UPDATE -- Safety Recall C45 - Floor Shifter Ignition/Park Interlock

Involved Vehicles: 1993-1997 (LH) Chrysler Concorde, LHS and
300M; Dodge Intrepid and Eagle Vision

Dealer Service Instructions for:

Safety Recall C45 **Floor Shifter Ignition/Park Interlock**

Figure 1

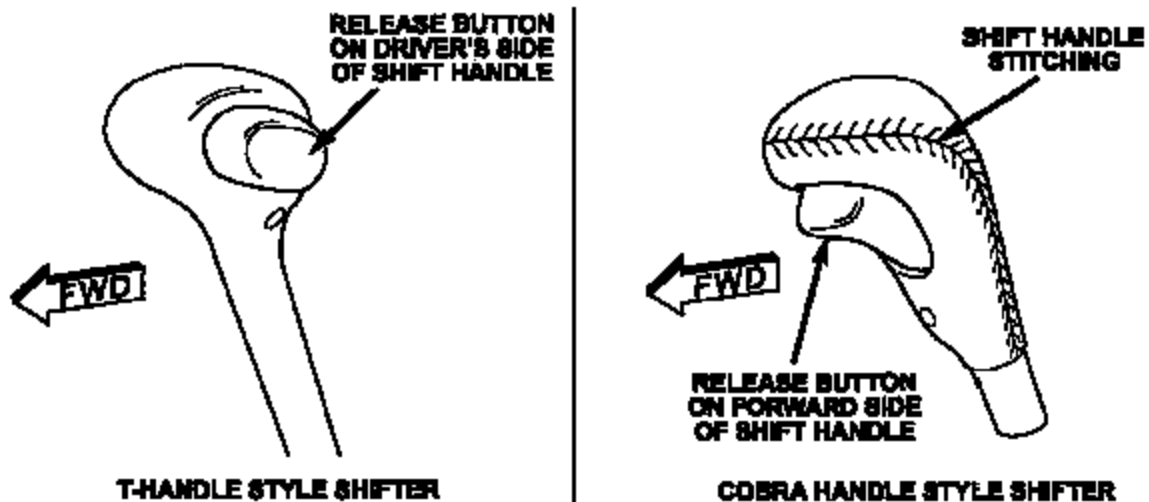
The Parts Section of the Dealer Service Instructions incorrectly specifies one of the LH Load Limiting Push Rod part number applications. The correct Load Limiting Push Rod part number information for all LH models is listed below.

. 1993 through 1997 LH vehicles EQUIPPED WITH A COBRA SHIFTER HANDLE require the long load limiting push rod, P/N CBWSC451 (NOT CBWSC452 as shown on Page 3).

This revision corrects the Load Limiting Push Rod part number application for 1993 – 1997 LH vehicles equipped with a Cobra shifter handle.

. 1993 through 1997 LH vehicles EQUIPPED WITH A T-HANDLE SHIFTER require the short load limiting push rod, P/N CBXTC453 (as shown on Page 3).

. 1998 and 1999 LH vehicles EQUIPPED WITH A COBRA SHIFTER HANDLE require load limiting push rod with the ball end, P/N CBWSC452 (as shown on Page 3).

Figure 4 – LH Model Shown

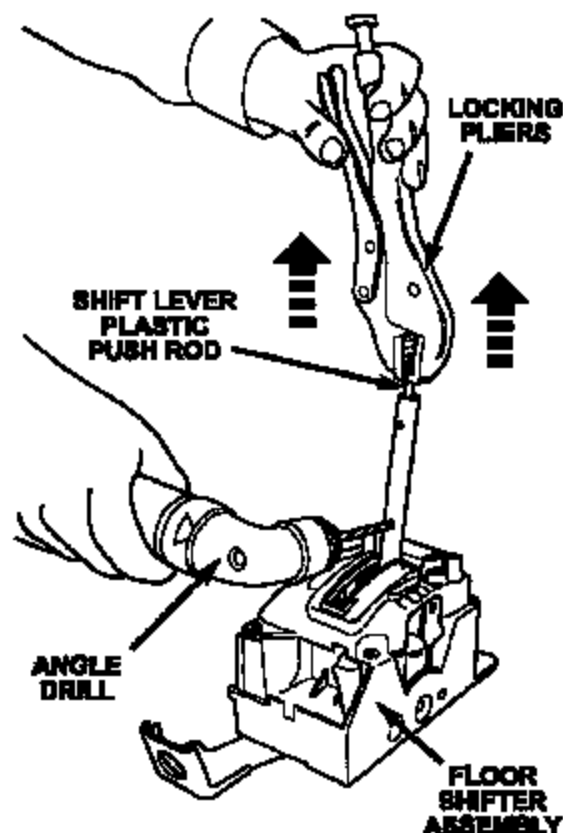
In order to assure that the proper Load Limiting Push Rod is being used, an additional step has been added to the dealer service instructions to verify that the original push rod and the new load limiting push rod are the same length.

13. Verify that the new load limiting push rod and the original push rod are the same length.
14. Discard the old push rod and preload spring.
15. For vehicles that had the dimple drilled out, use a small round file to remove any remaining metal burrs from the inside of the shift lever at the hole drilled in Step 9 (Figure 5).
